# **Byron Unit 1 Extended Cycle 8 Report**

**ComEd**

**October 1996**

### **BYRON UNIT 1 RESPONSE TO**

Figure 27a: Distribution of Average Volts Percent Error, Calls with > 100% Error Removed

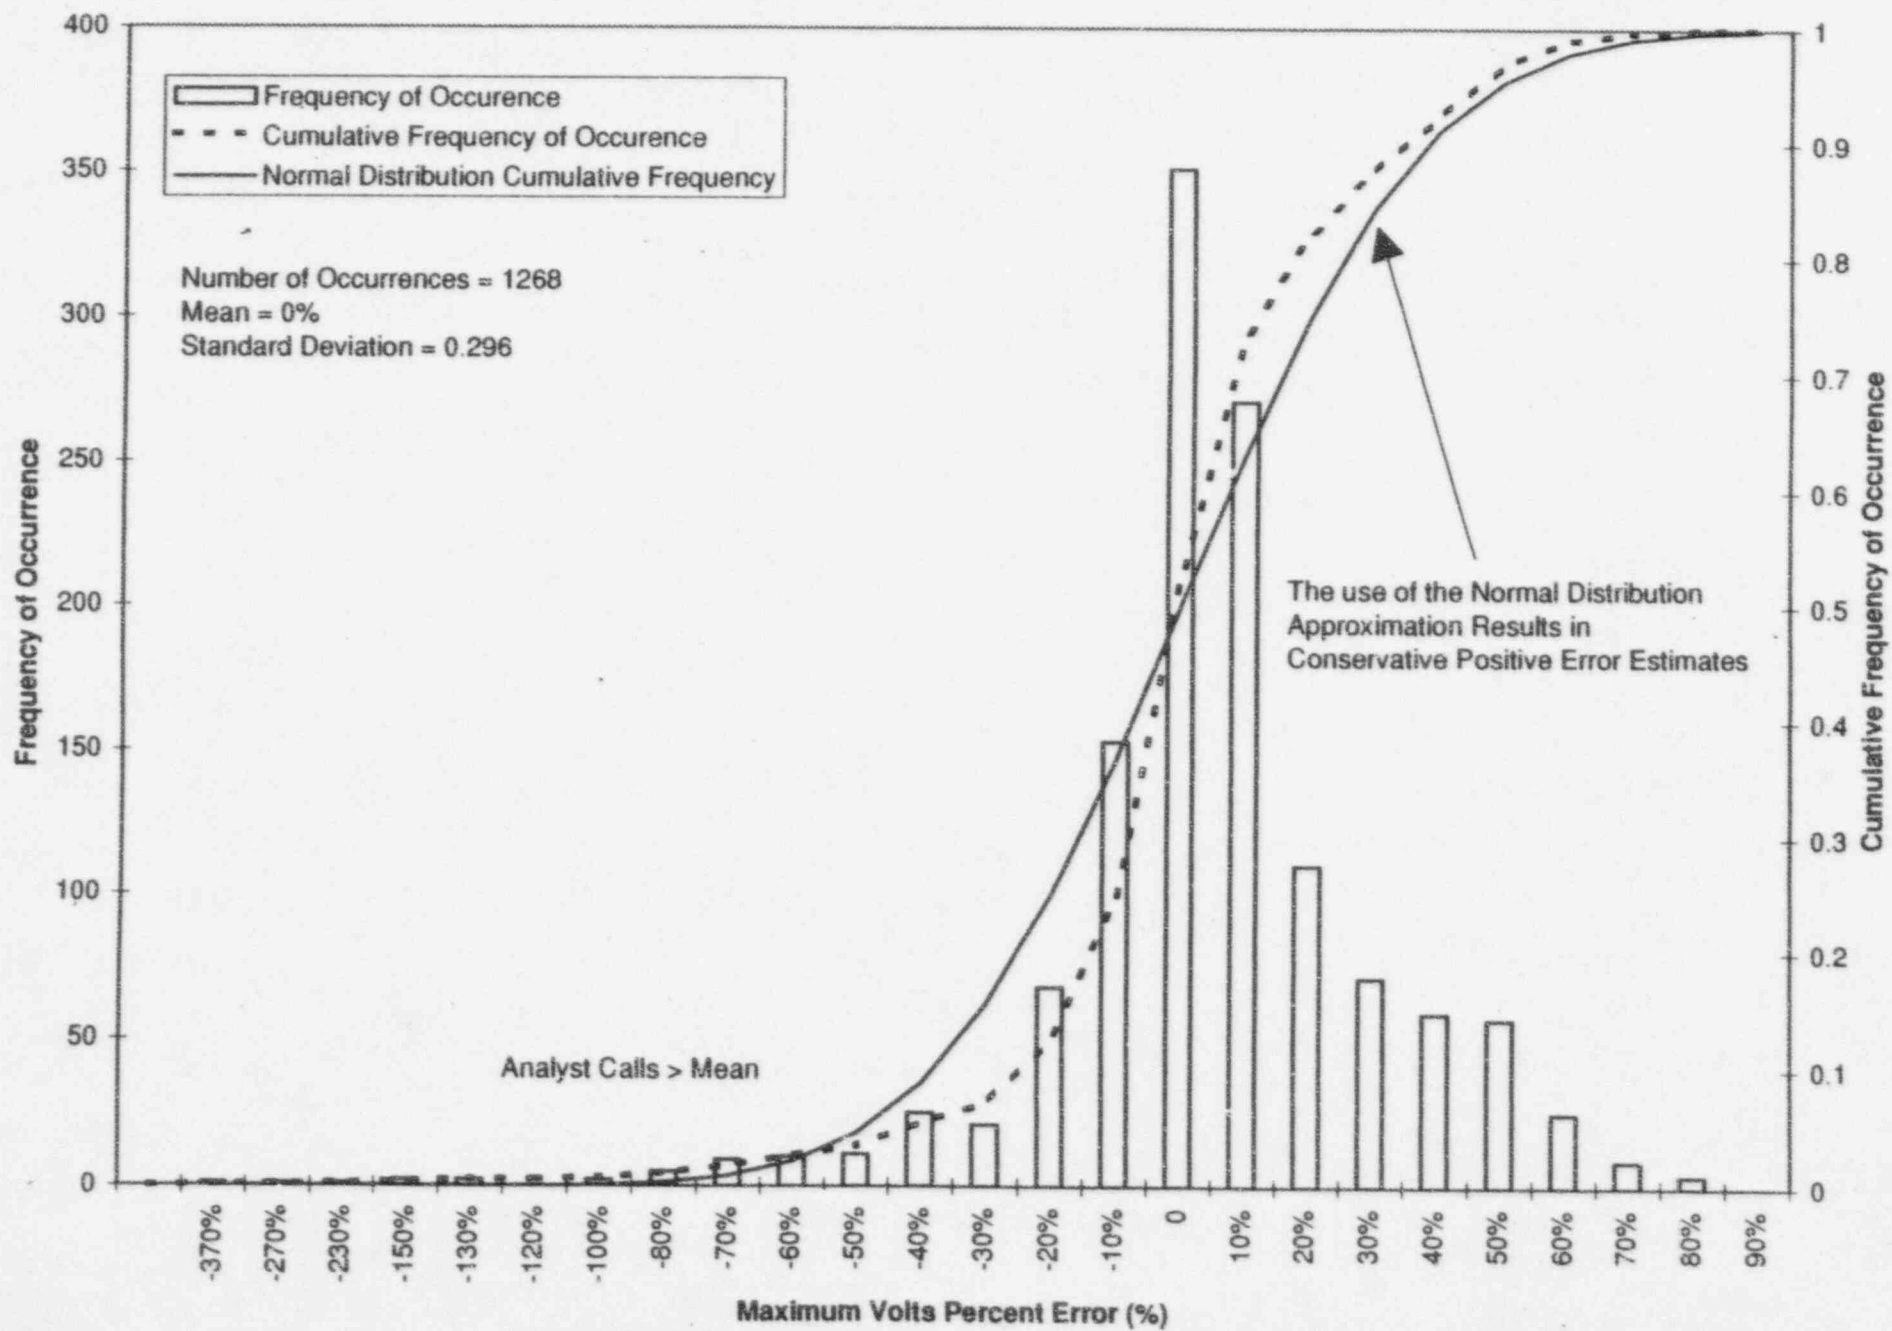
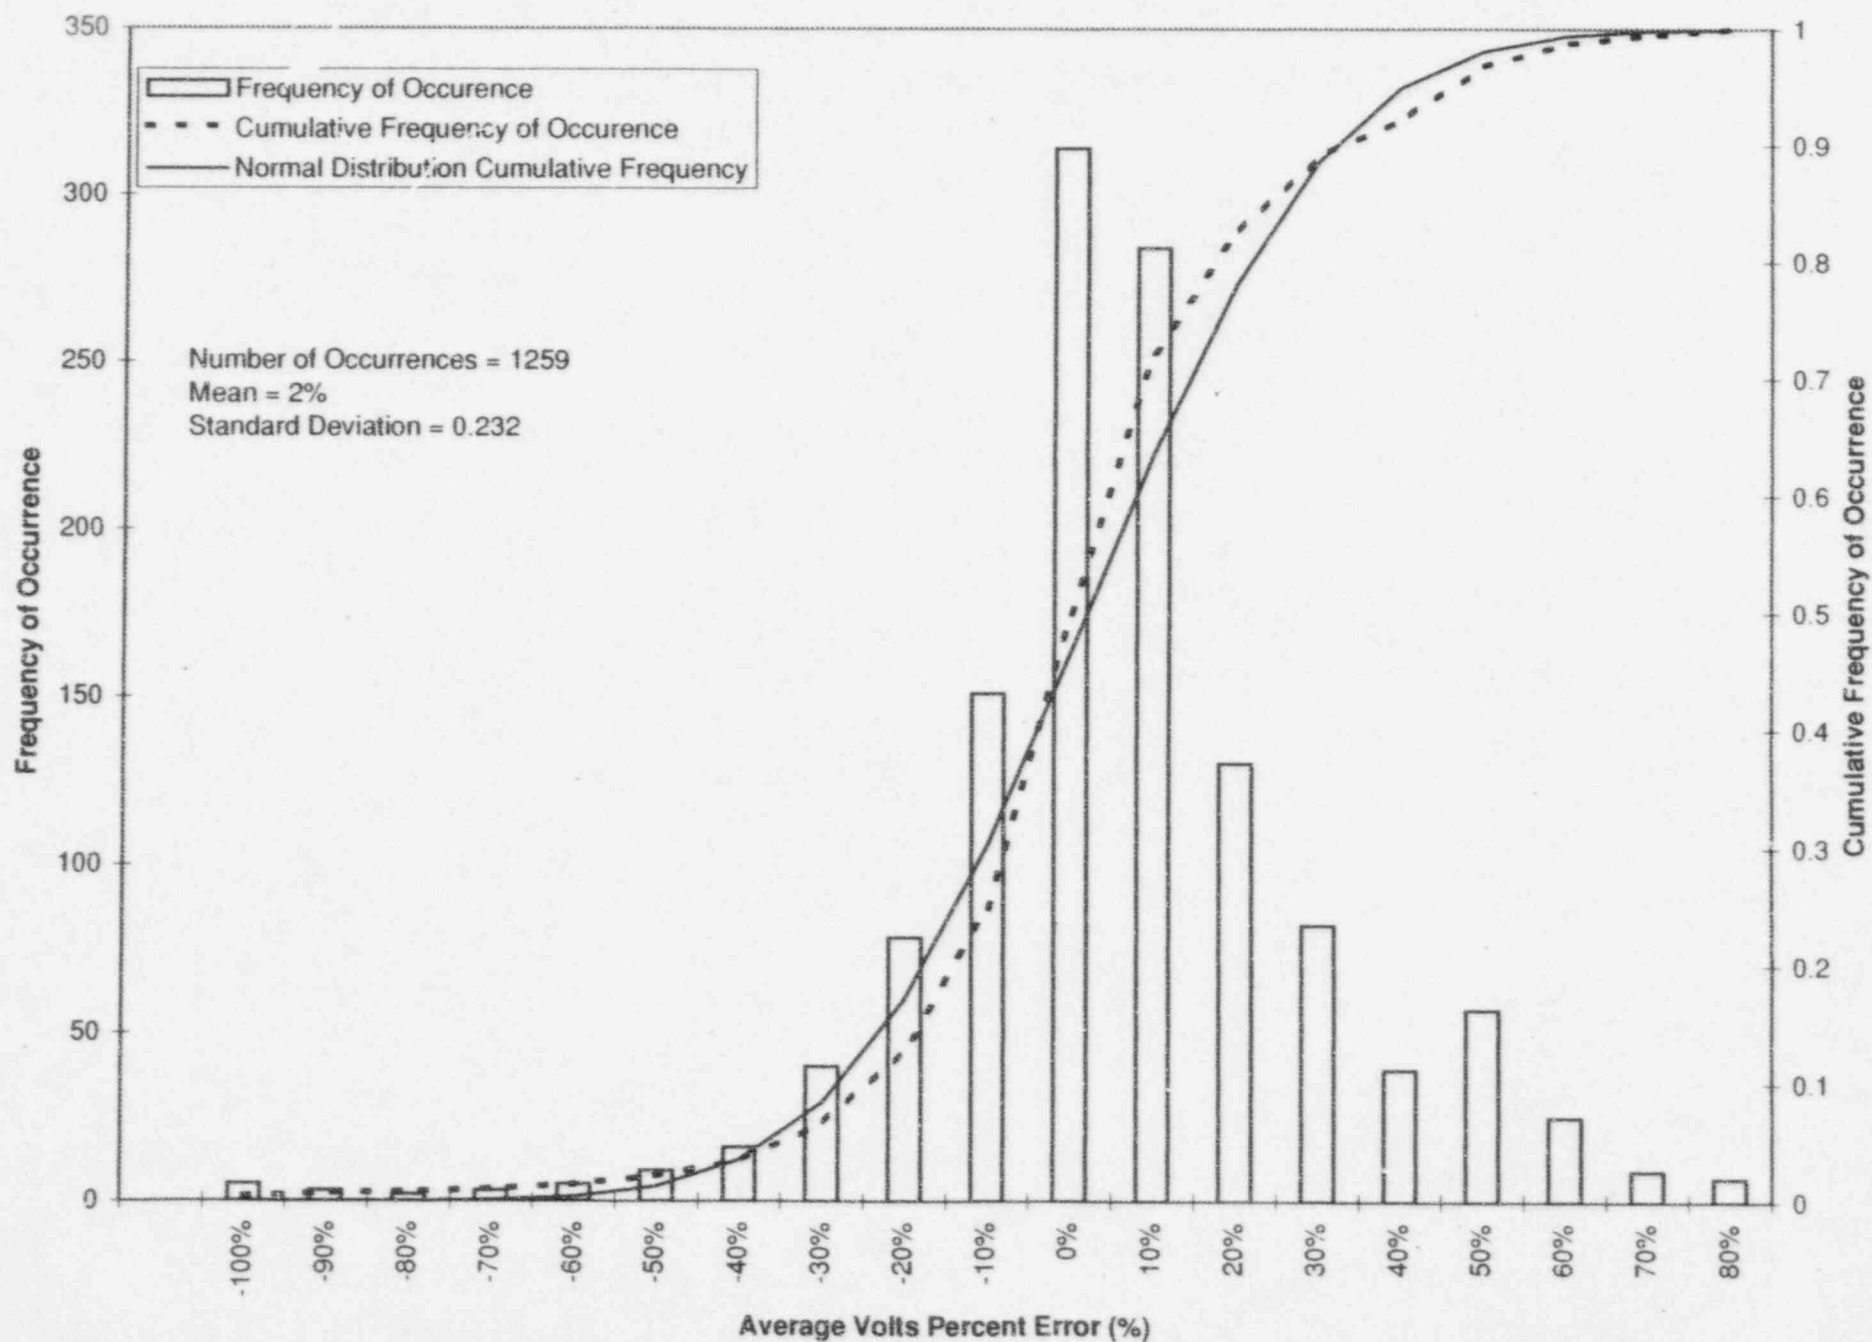
27. **Discuss the basis for reevaluating the EC voltages measured in the analyst variability study based on a resolution process. Discuss whether this practice was used in the blind tests. The staff believes that this method of analyzing analyst variability is inconsistent with the methodology used in GL 95-05 (i.e., reevaluating the EC voltages). Clarify what is meant by the statement that observation EC voltages from different coils for the same indications were excluded.**

- In order to evaluate the affects of resolution of blind test results, voltages with a percent error greater than -100% (these represent conservative calls with voltages recorded greater than the mean voltage) is applied to the data to provide a realistic assessment of the analysis results. Application of this resolution process results in a standard deviation of percent analyst error of 0.23 for average volts and 0.24 for maximum volts. The resulting distribution after resolution is shown in Figures 27a and 27b for average and maximum voltage, respectively. The figures show that the distribution is more normal after the resolution.
